# UNITED STATES PATENT AND TRADEMARK OFFICE

<b>Office Action Summary</b>	Application No.	Applicant(s)	
	10/768,382	BREMMON ET AL.	
	Examiner	Art Unit	
	Jon A Szumny	3632

This is the first office action for application number 10/768,382, Universal Mount Bracket, filed on January 29, 2004.

Application number US 2002/0033436 to Peng et al.

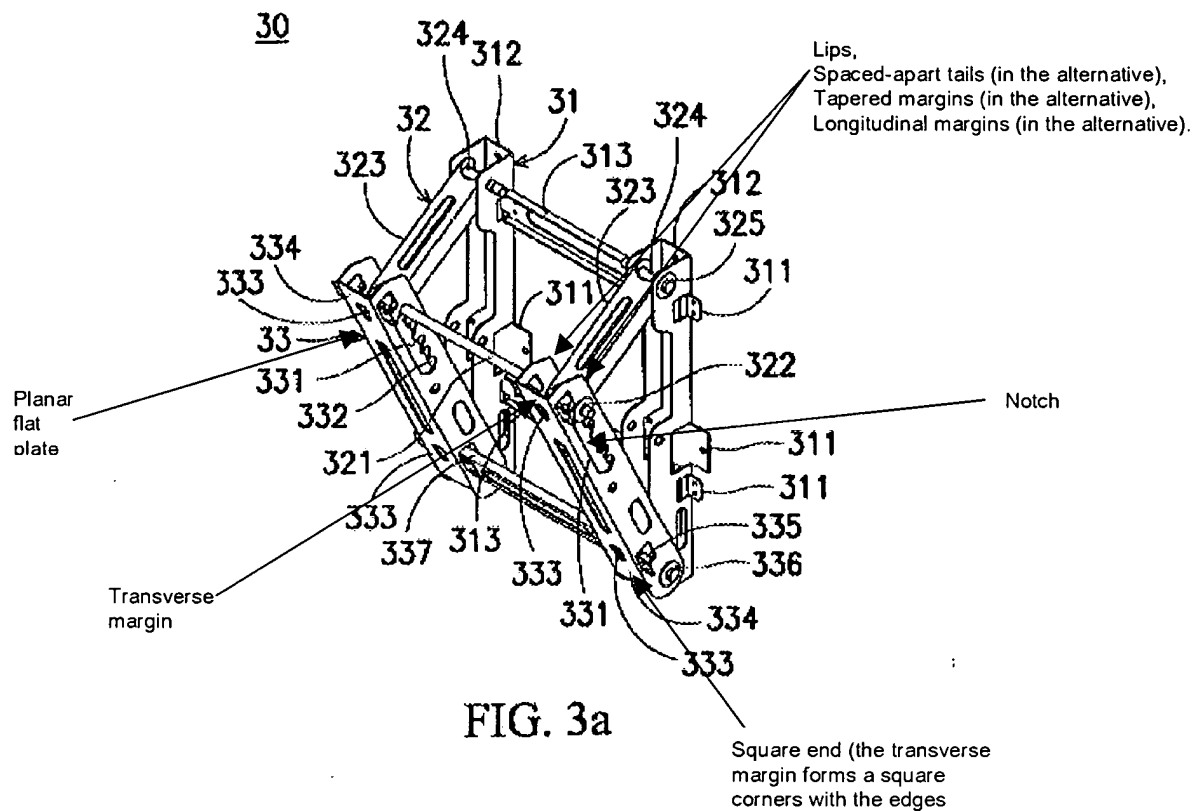
Regarding claims 1-4 and 8-11, Peng et al. '436 divulges a mount (above) for mounting a flat panel display (40) comprising a mount structure (312, left and right sides) shiftably coupled (via 323, left and right sides) to a pair of mount brackets/mount bracket set (334, left and right sides) each having a substantially planar flat plate (above) with a series of mounting bores (333) defined therein, wherein each bracket is a mirror image of the other mount bracket, wherein each bracket has a lip (above) formed along first and second longitudinal side margins.

With respect to claims 5 and 12, Peng et al. '436 alternatively teaches each mount bracket to have a square and opposed ends, the opposed end having a transverse margin and two spaced apart tails (above).

With respect to claims 6 and 13, Peng et al. '436 alternatively teaches each mount bracket to have a square and opposed ends, the opposed end having a transverse margin and a tapered margin adjacent the transverse margin (above).

With respect to claims 7 and 14, Peng et al. '436 alternatively teaches each mount bracket to have a notch (above) defined in a longitudinal margin.
